Addendum No. 4 Rev. 2

To: International Buddhist Progress Society of Ottawa – Carleton
From: Egis Group Ltd. (formerly McIntosh Perry Consulting Engineers Ltd.)
Date: August 29, 2025
Re: Additional Technical Information to the Revised Geotechnical Report Issued January 2019–
IBPS - 6688 Franktown Rd Richmond

This is an addendum to the revised Geotechnical Report, dated January 2019, which is included in Appendix E. It provides updated recommendations for the foundation design of the proposed temple building, based on the new architectural and civil drawings provided by the International Buddhist Progress Society of Ottawa (the client), which reflect the building's relocation. This addendum must be read in conjunction with the revised report. The additional information and recommendations are presented below. The included information does not replace that which already exists in the revised January 2019 report but serves to augment or update as necessary.

date	DECEMBER 18, 2024	job. no. 0623
scale	As indicated	
drawn	CM	drawing no. A002
approved	AL	
plot date	12/18/24

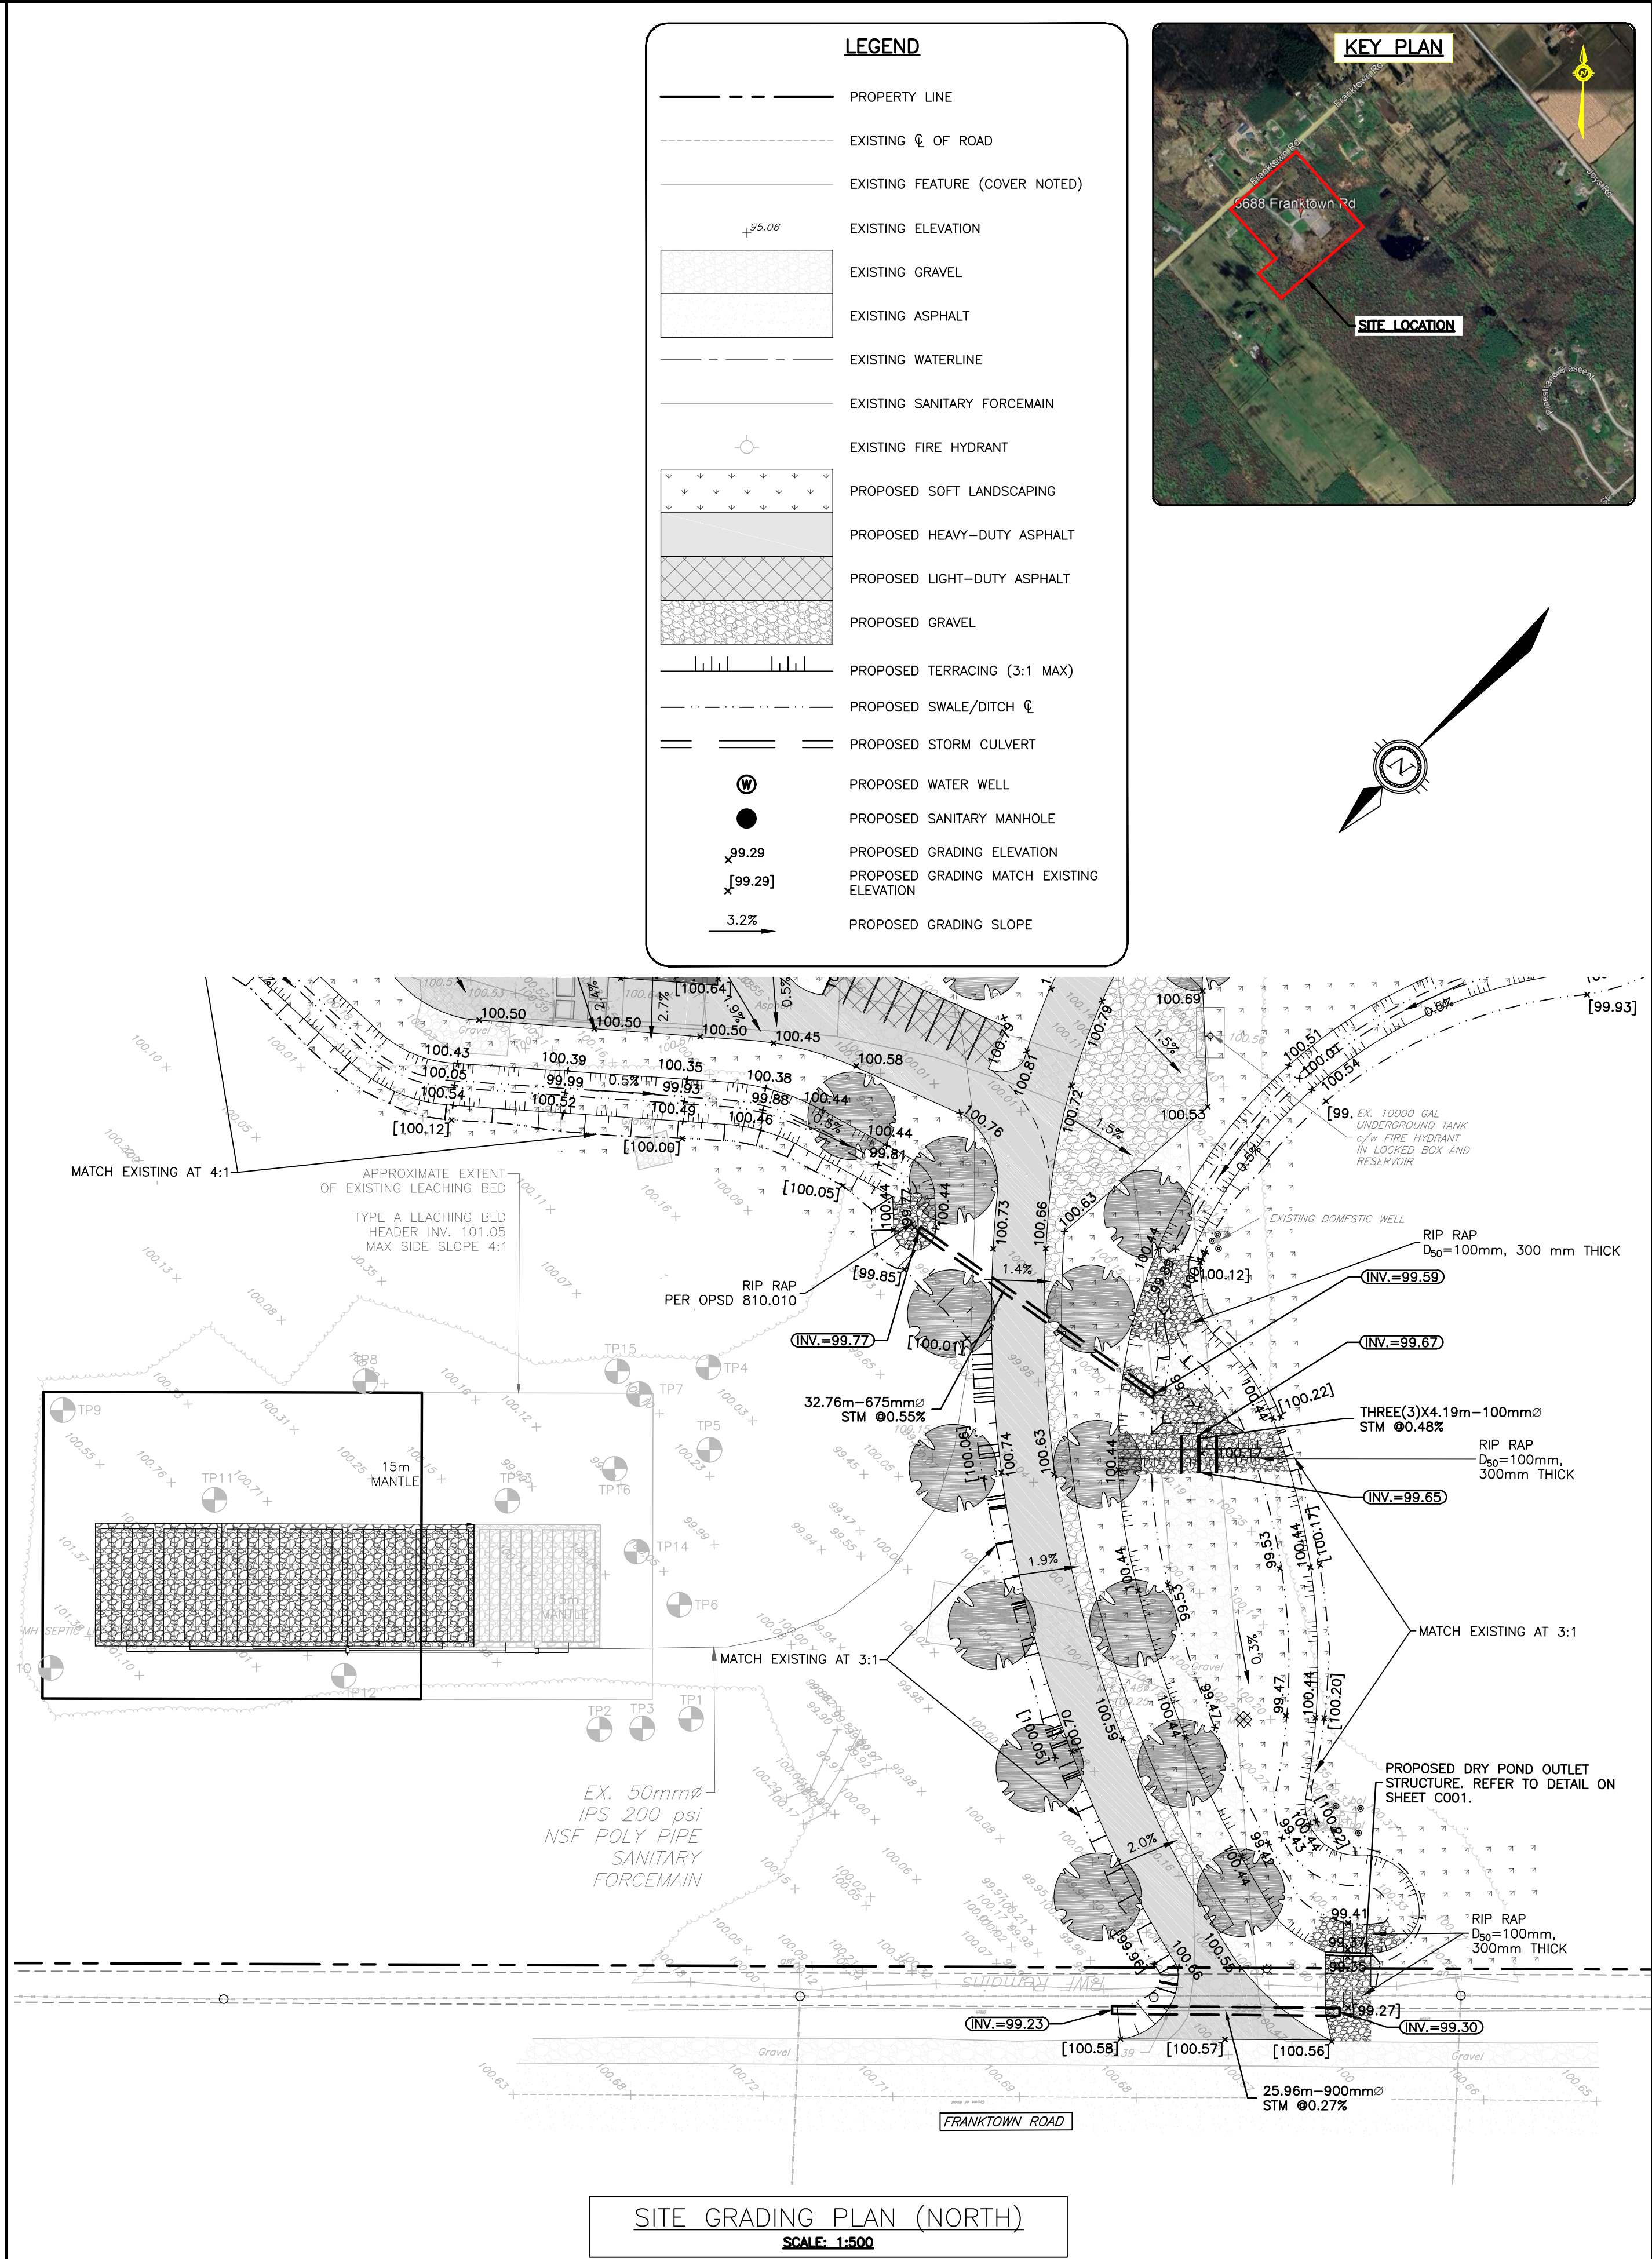
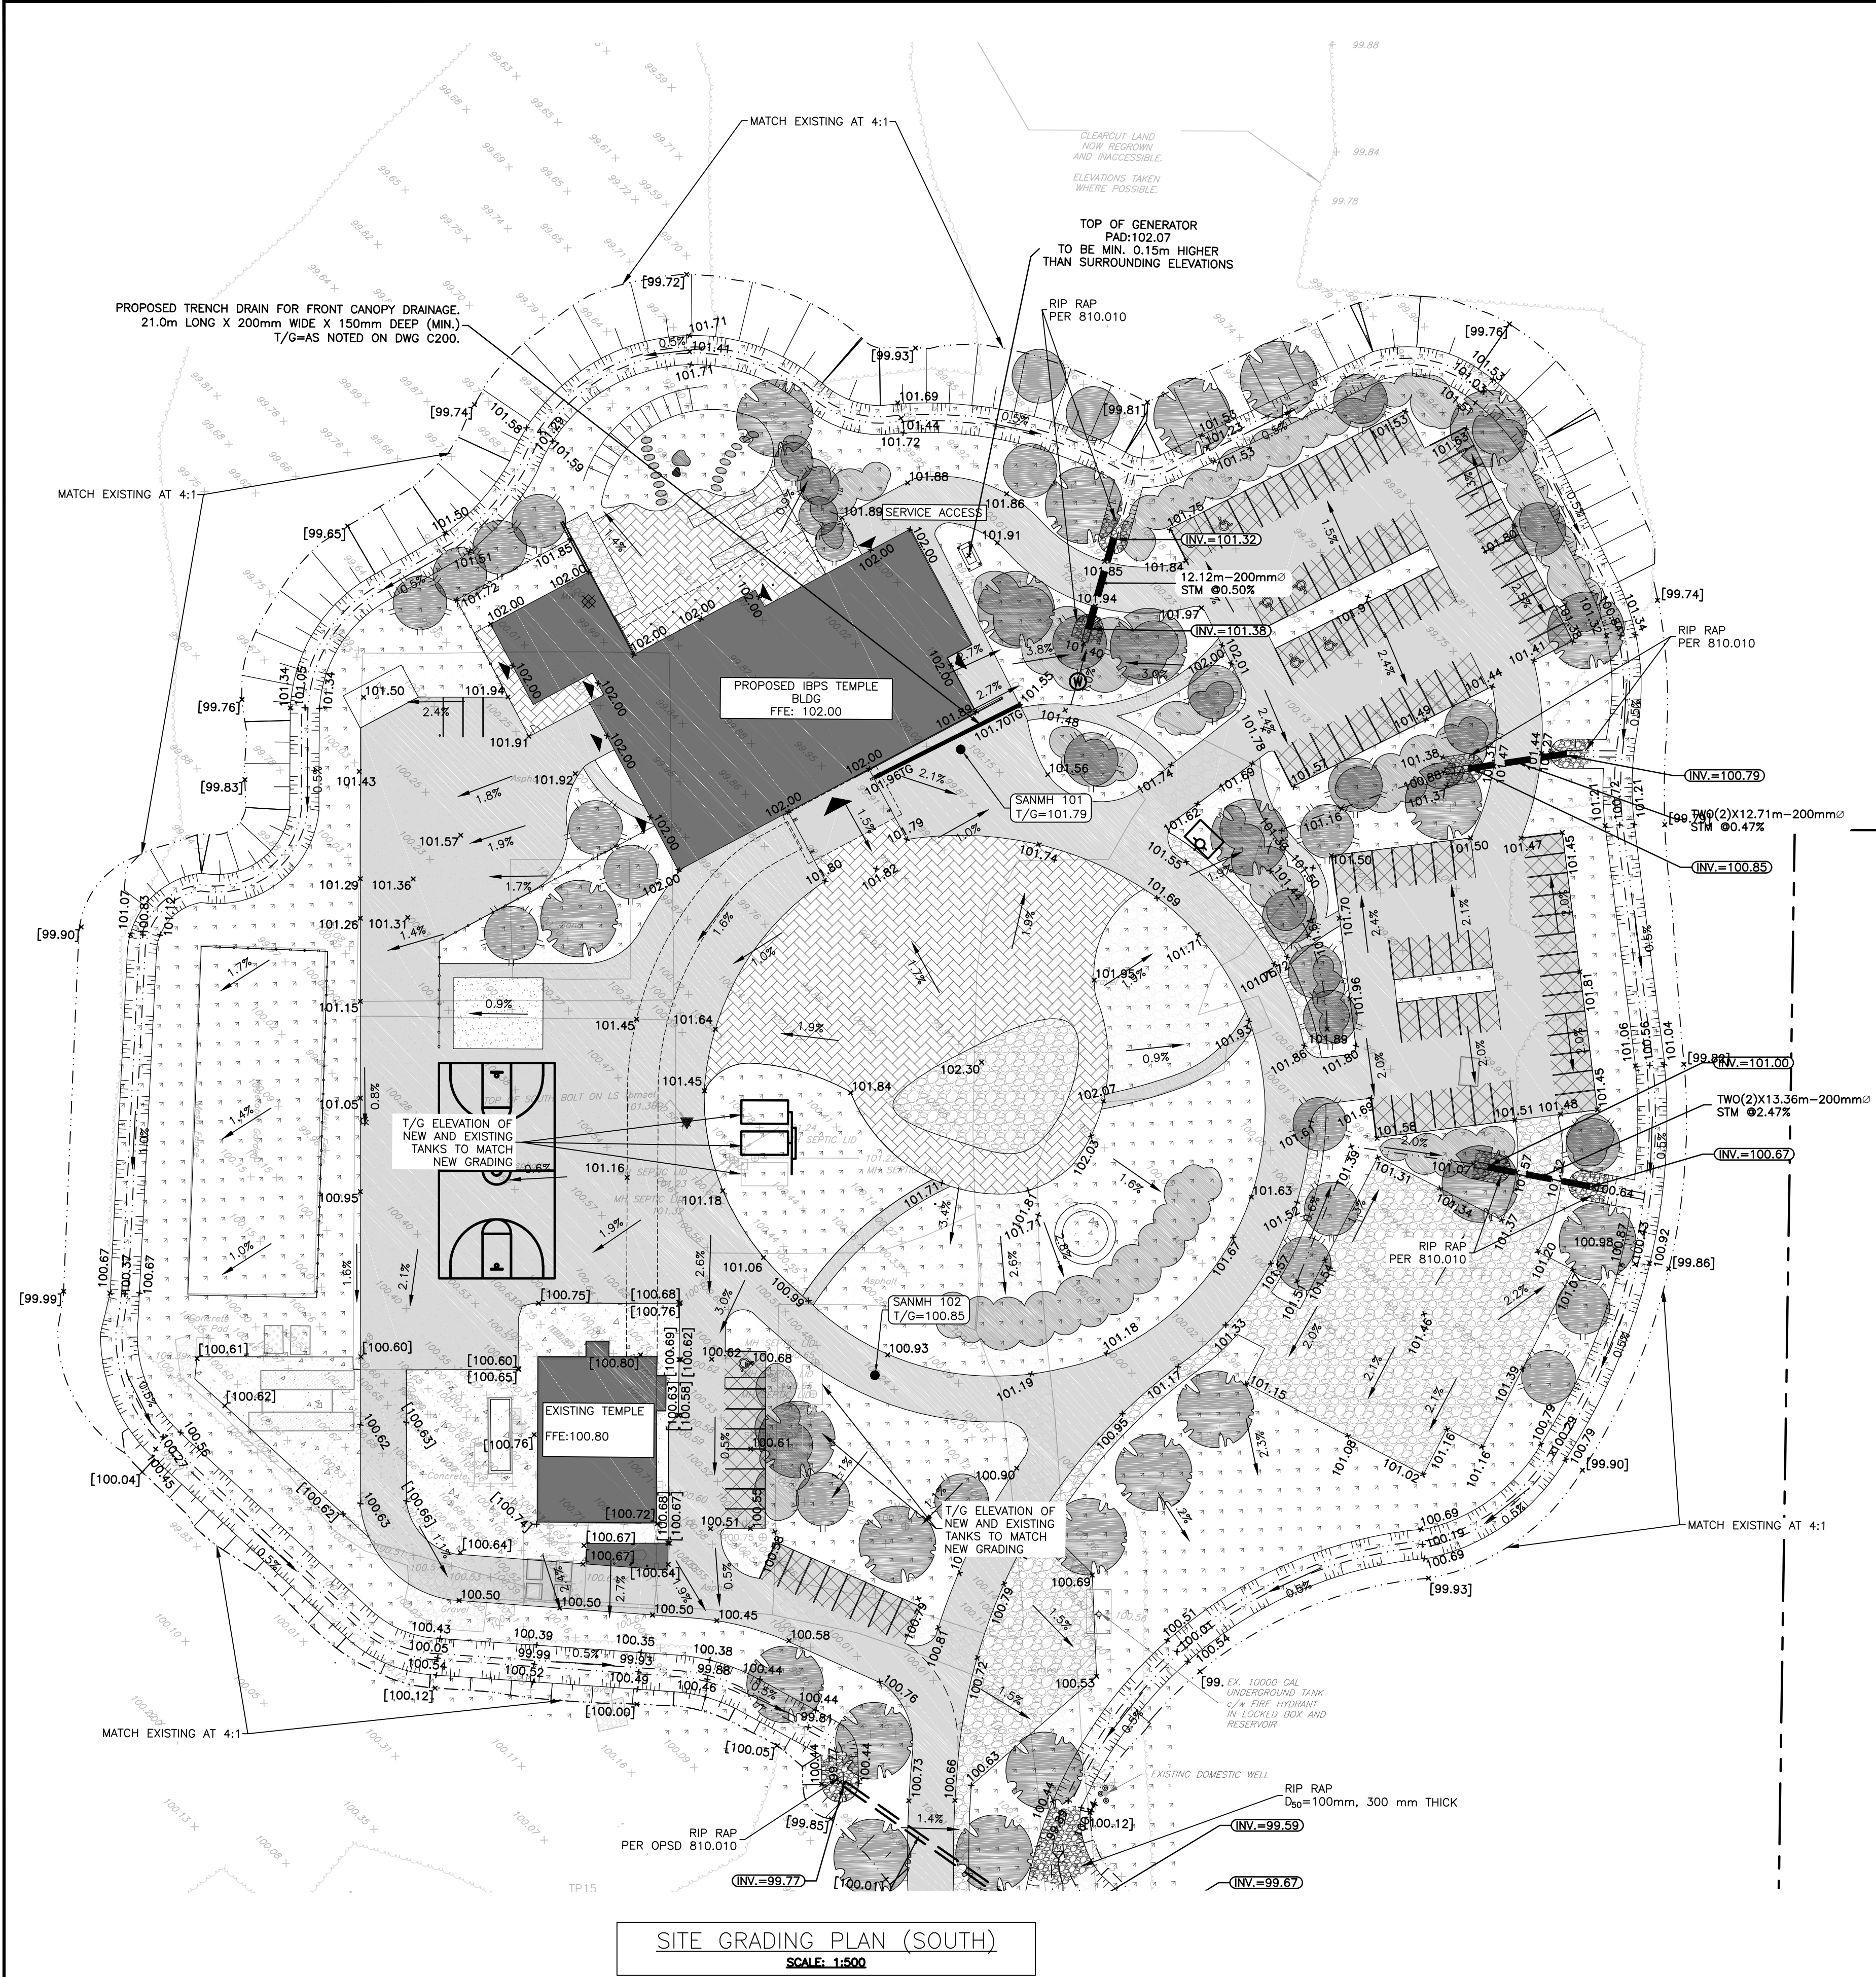
- Based on the architectural site plan A002 Rev. 1 (included in Appendix C), prepared by GRC Architects, dated December 18, 2024, provided by the client, the temple building will be a single-storey structure with no basement, with an approximate footprint of 1,398 m². The new location of the building, as indicated in the site plan, is supported by the borehole data shown in Appendix A. Specifically, boreholes BH18-1, BH18-2, and MW18-1, located within the building footprint, remain valid and provide the necessary geotechnical data for the foundation design.
